## Re: Requerimiento de Información Núm. 2023-0054

**EMISION DE COMENTARIOS SOBRE LAS OBRAS DE ADECUACION A REALIZARSE  
ESCUELA CENTRAL DE ARTES VISUALES/CENTRAL HIGH SCHOOL, SANTURCE  
SAN JUAN, PUERTO RICO**

PROPIEDAD: ESCUELA CENTRAL DE ARTES VISUALES / CENTRAL HIGH SCHOOL  
SANTURCE, SAN JUAN, PUERTO RICO

**1. Vista general de la cancha.**

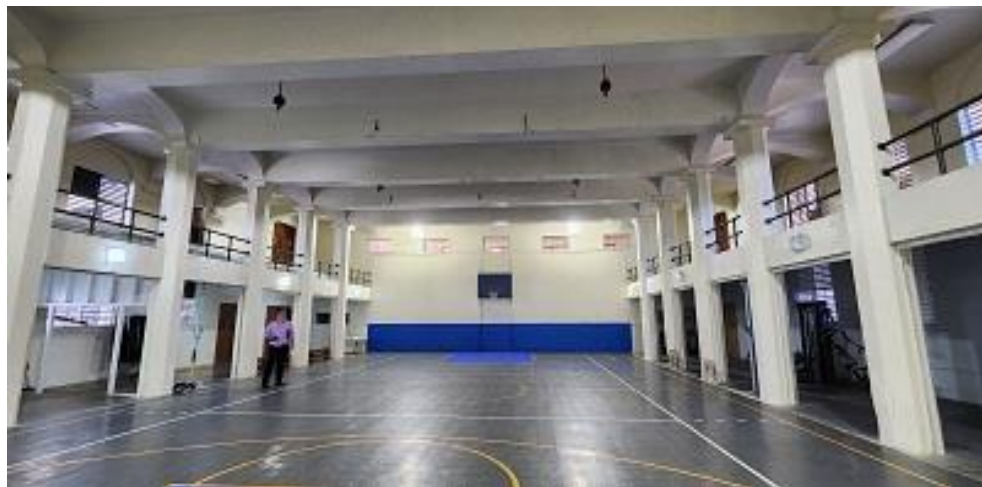
- 1) Las columnas de la cancha bajo techo que sostienen el plafón y a su vez el piso y estructura del teatro presentan daños en su parte baja por corrosión de los refuerzos de acero. Esta condición debe de atenderse por profesionales conocedores de la materia que garanticen una solución que resuelva esta condición. Esto aplica de la misma forma con los plafones debajo de las gradas en las áreas laterales del primer nivel.
- 2) Se sustituirán las dos unidades de aire acondicionado del teatro. En el tiempo que tome la sustitución de las unidades mediante la compra de las nuevas dos unidades, se podrá instalar una unidad temporera de alquiler. Esta última acción podrá ser sometida directamente al ICP-PPHE para la evaluación y acción correspondiente. Como parte de las obras de sustituciones de las unidades, se volverá a pintar los tubos de metal del cerramiento del área donde se ubican.
